Project: Contract No. W912DQ-08-D-0018  
Task Order No. 3, WAD 12  
Federal Creosote Superfund Site  
Operable Unit 3 - Groundwater

Subject: Final Groundwater Monitoring Report  
Long-Term Monitoring Program - Year 3

***Groundwater Monitoring Report  
Long-Term Monitoring Program – Year 3***

## Response to Comments

# Appendix A

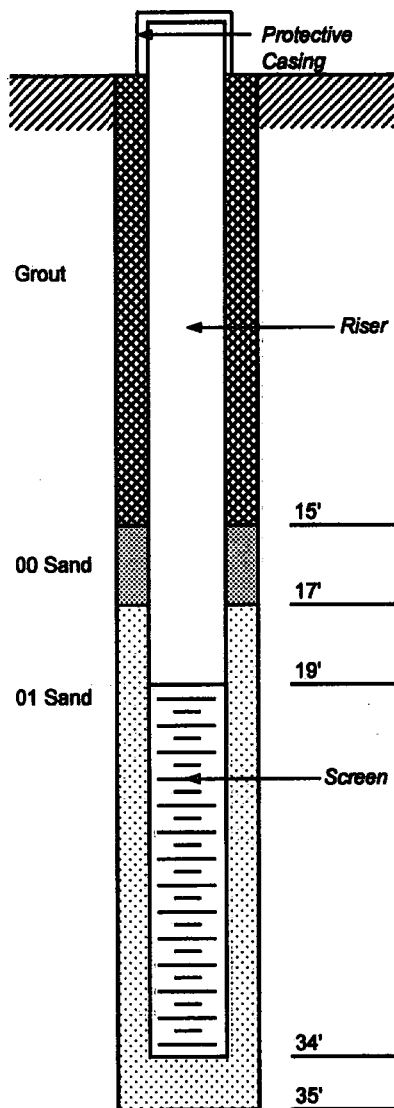
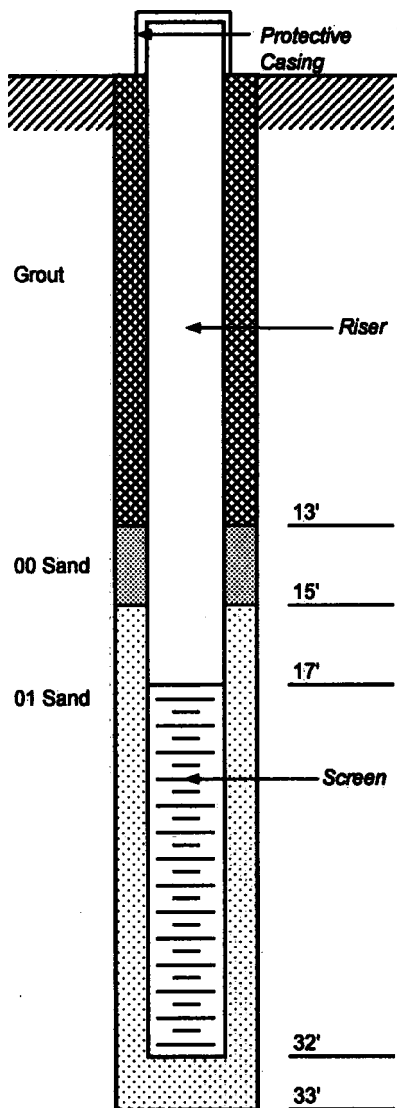
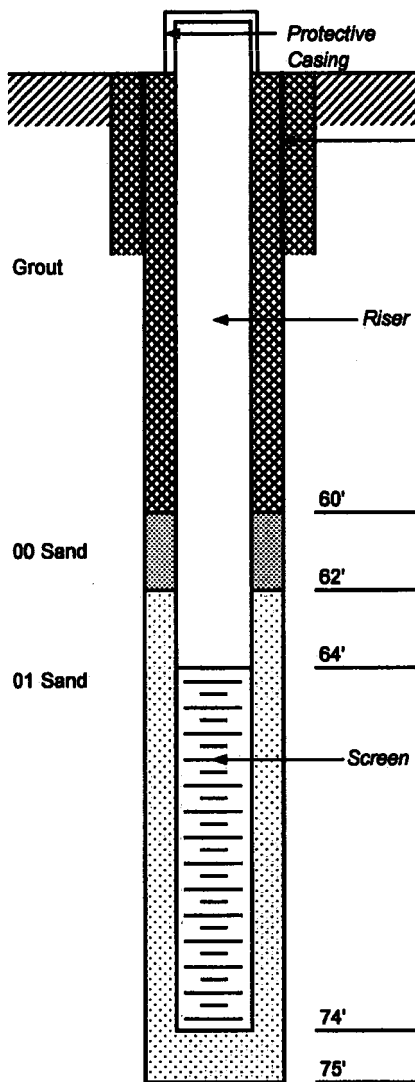
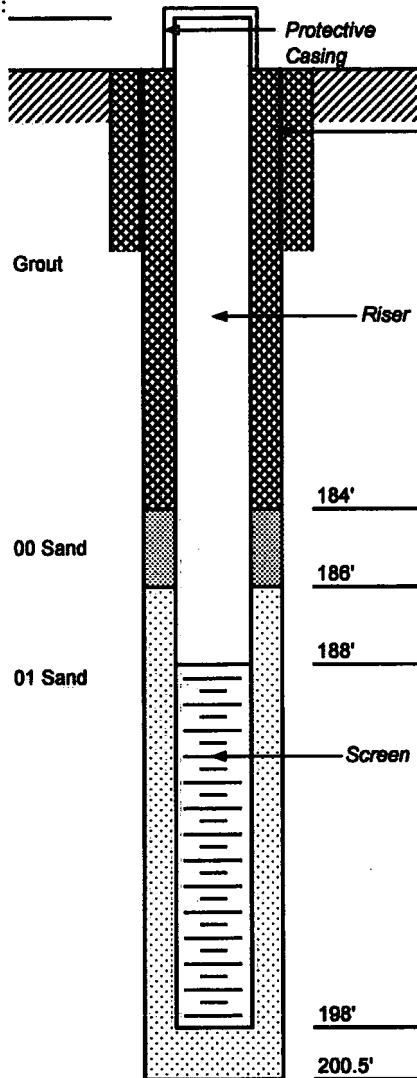
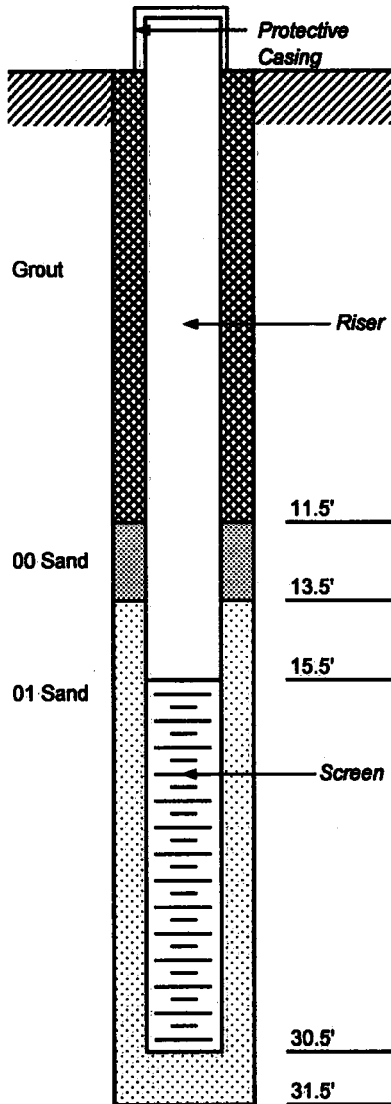
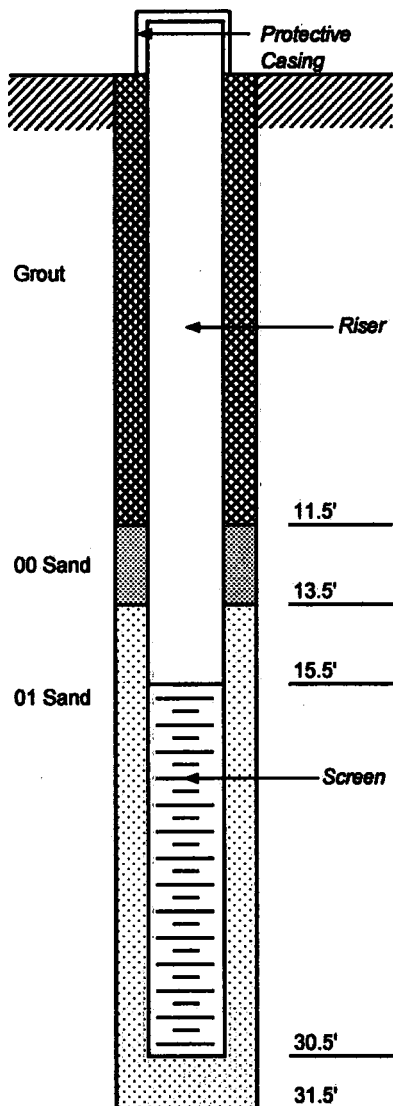
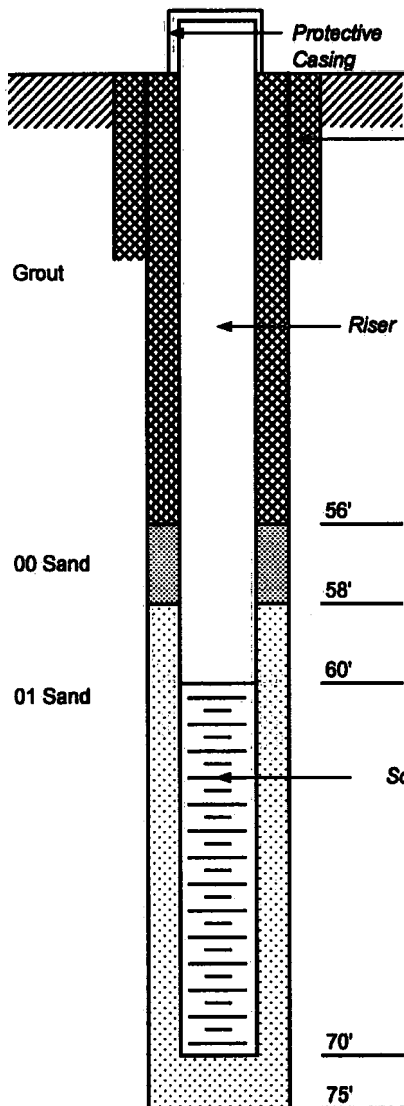
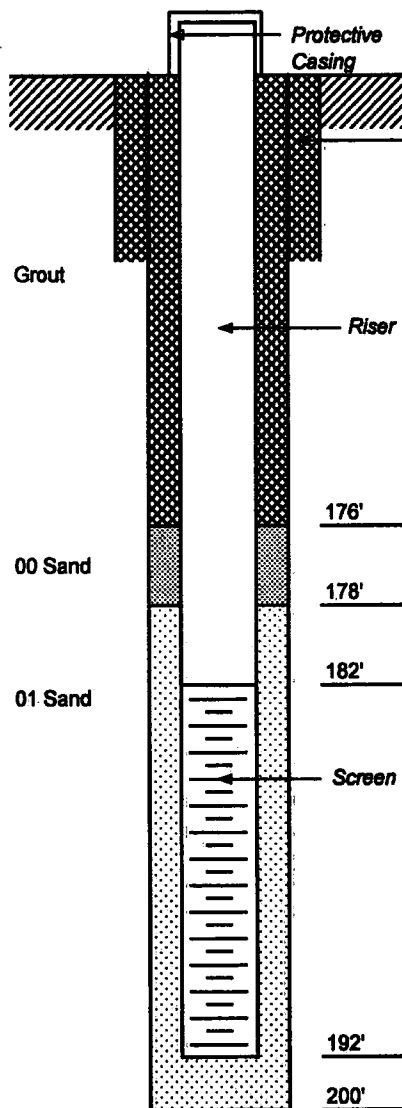
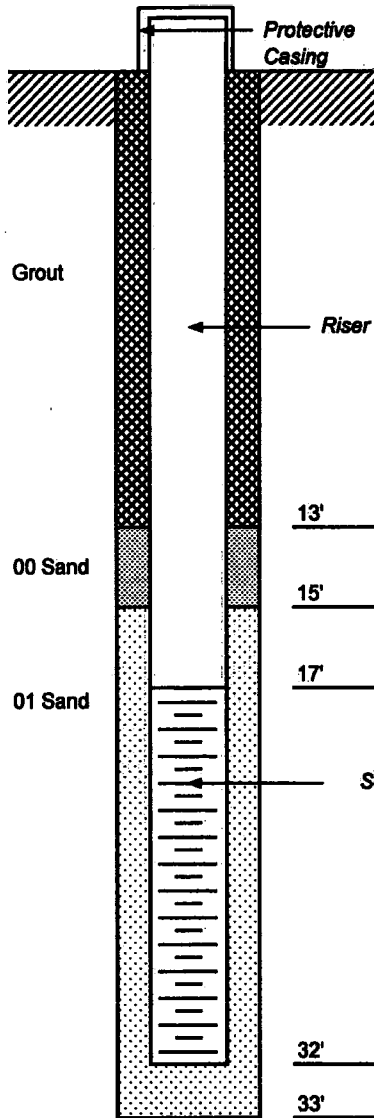
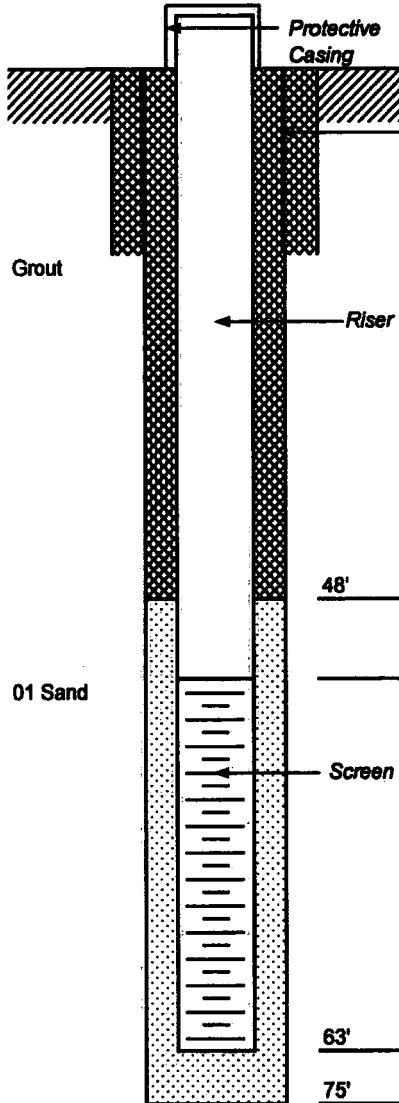
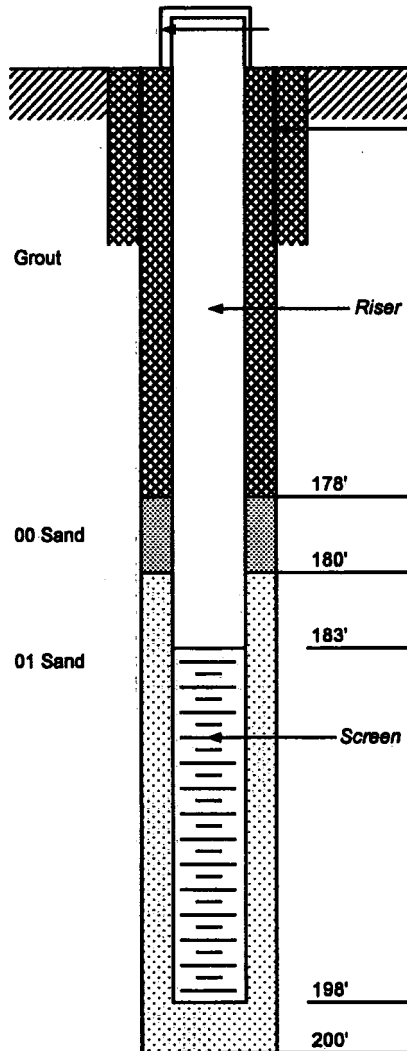
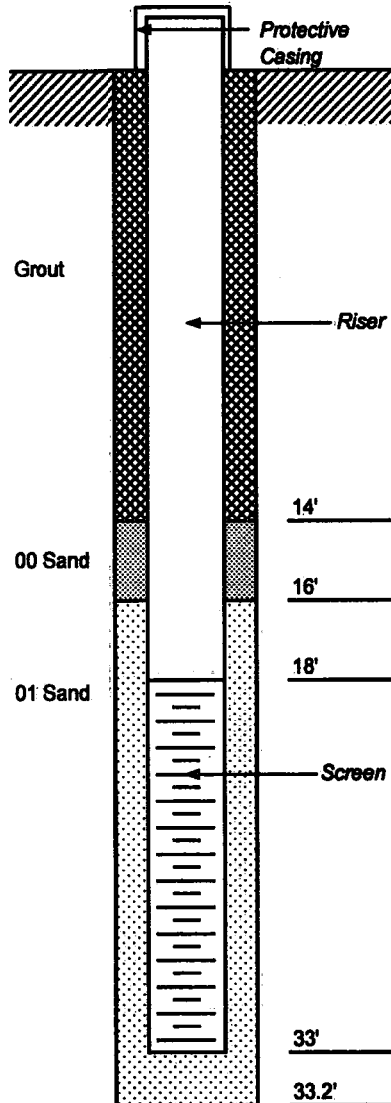
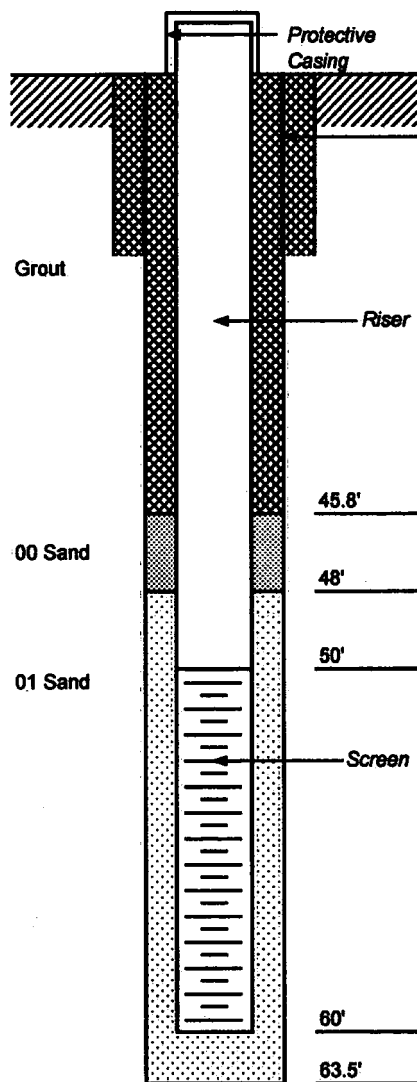
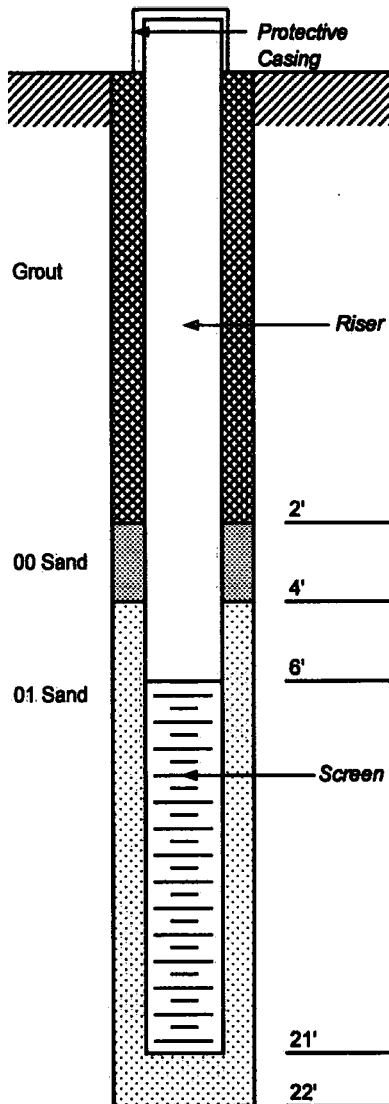
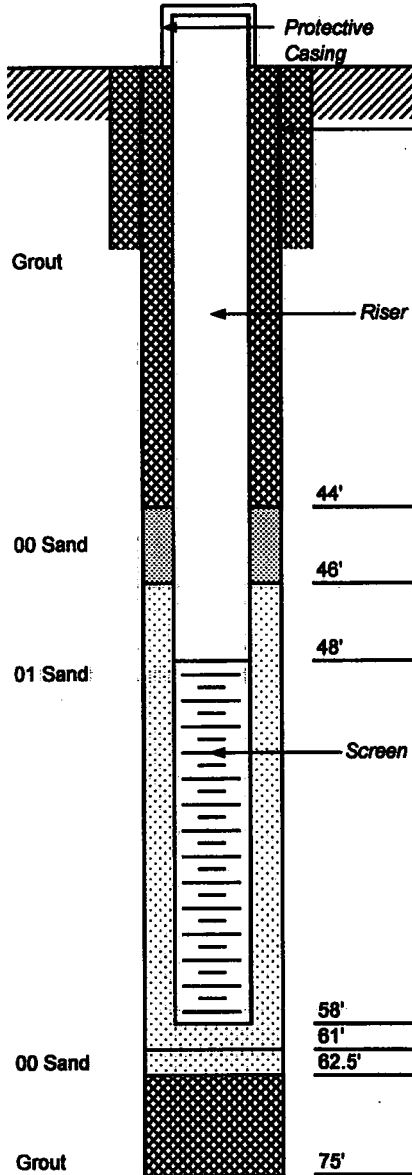
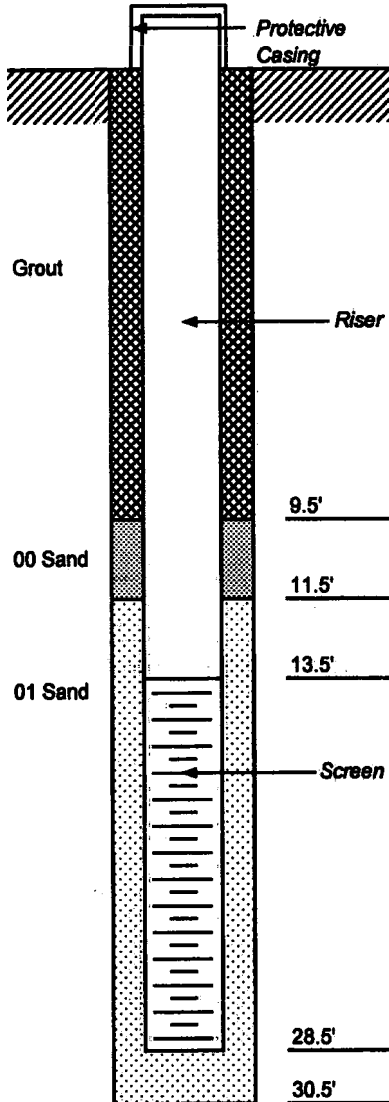
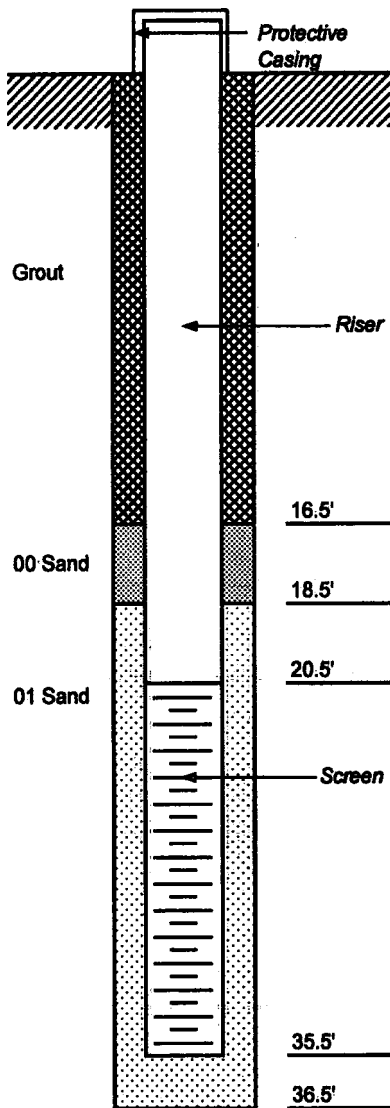
**Comment 5:** Appendix A - Well Construction Diagrams. The well construction diagrams are incomplete with respect to material suppliers/manufacturers, material qualities and mix ratios, measurements of well materials (well casing and screen, filter pack, grout, etc) and placement intervals

Additionally well development logs were not provided to document stabilization parameters during and after development completion, equipment used (pump and surge block), length of time of each development cycle and pumping rate was not consistently identified. Please provide.

**Response:** CDM does not generally include material suppliers/manufactures, material qualities and mix ratios on our boring logs and does not intend to include that information. Measurements and placement intervals are included as text beside the graphic, but the specific measurements will be transposed to the table to the right of the graphic.
